**NILES CANYON TRAIL PROJECT
RESPONSE TO COMMENTS AND FINAL
ENVIRONMENTAL IMPACT REPORT**

STATE CLEARINGHOUSE NO. 2021060647

ALAMEDA COUNTY, CALIFORNIA

November 2024

FIGURE 3-9a

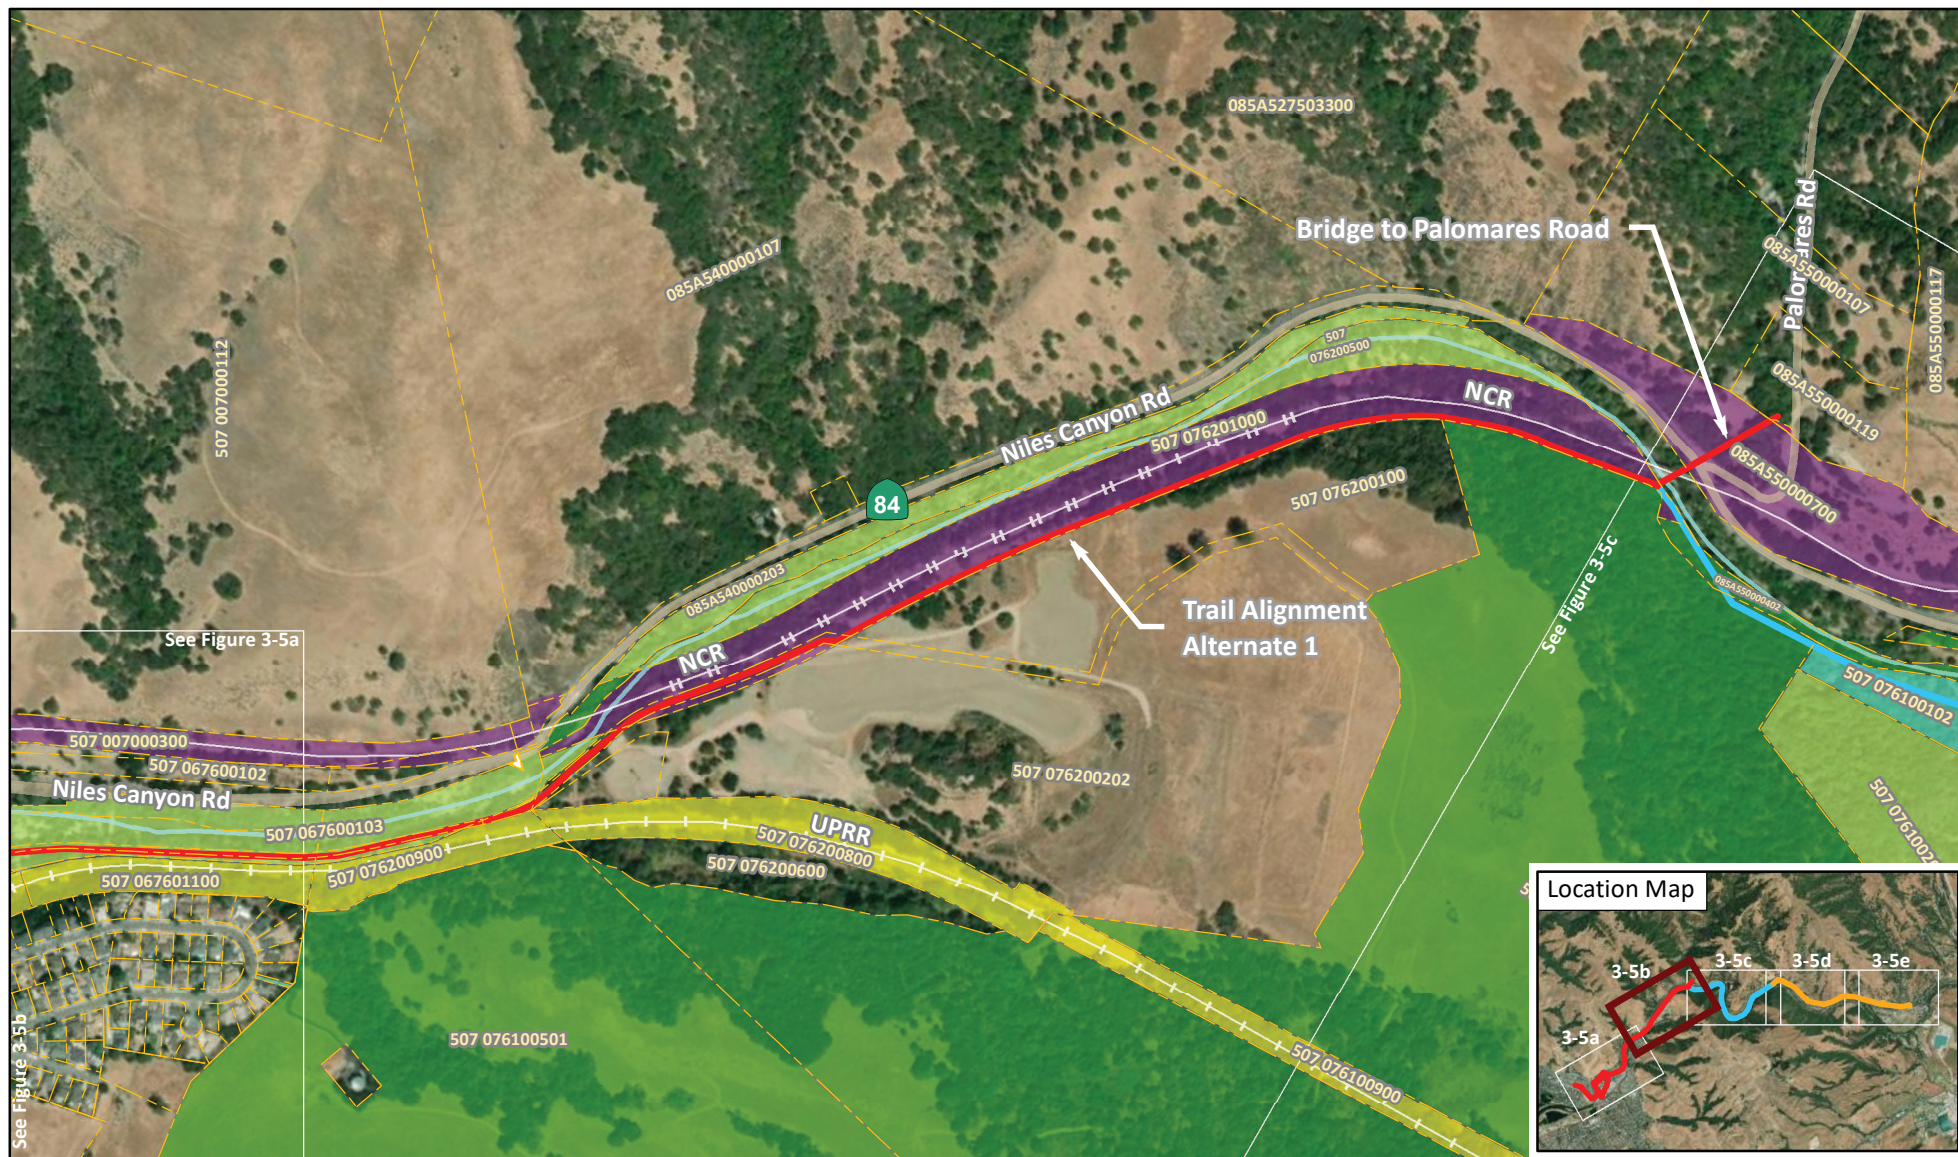
6. Parcel Ownership: Figure 3-9a shows several parcels along the Alameda Creek Flood Control Channel that are incorrectly attributed to ACWD ownership. Please coordinate with ACWD to correct this map prior to finalization of the EIR.

Response A-1-17. The comment requests revisions to Draft EIR Figure 3-9a showing parcel ownership. In response to this comment, Figure 3-9a on page 3-39 of the Draft EIR is revised to correctly depict ACWD's parcel ownership, as shown on the following page. These revisions represent a minor change to the Draft EIR in order to clarify the Draft EIR analysis. These revisions do not change the conclusions or analysis of impacts in the Draft EIR.
